Product Change Notification

Date Issued :	September 16, 2026	PCN Number :	518783
Reason for Change :	Manufacturing Process Change		
Description of Change :	This notification is an addendum to PCN 518243, communicated to impacted customers on 02-Jul-2026, informing that Molex Lincoln Nebraska is making a change in the plating for the terminals used in parts on the attached impact list. The addendum is to add 7 part numbers that were missed in communication of PCN 518243. This change will be from Bright Tin to a Matte Tin finish on the impacted terminals. There will be no impact to any Form, Fit, or Function based on this plating change but there will be an impact on the Appearance. This PCN (518783) is only communicating to the customers impacted by the 7 added parts.		
Assessment of Change :	Electrical Analysis		
Planned Implementation Date :	March 26, 2027		
Customer Sample Availability Date:	December 04, 2026		
Last date to request Samples by Customer : September 25, 2026

Addendum to PCN 518243

Change in plating chemistry from Bright Tin→Matte Tin

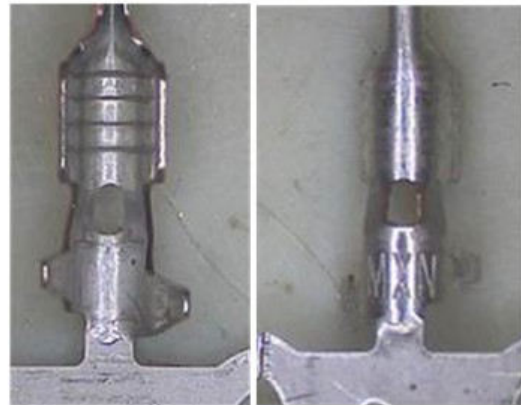
Current Bright Tin Plating Finish

Future Matte Tin Plating Finish

- Molex Lincoln Nebraska is standardizing the matte tin plating for all CP 0.64/1.5/2.8 terminals, as bright tin chemistry is being phased out of our plating operations. While this results in a change in product appearance, all form, fit, and functional performance requirements remain unchanged.

- No impact to Fit, Form or Function
- Appearance will be impacted (Bright Tin to Matte Tin)
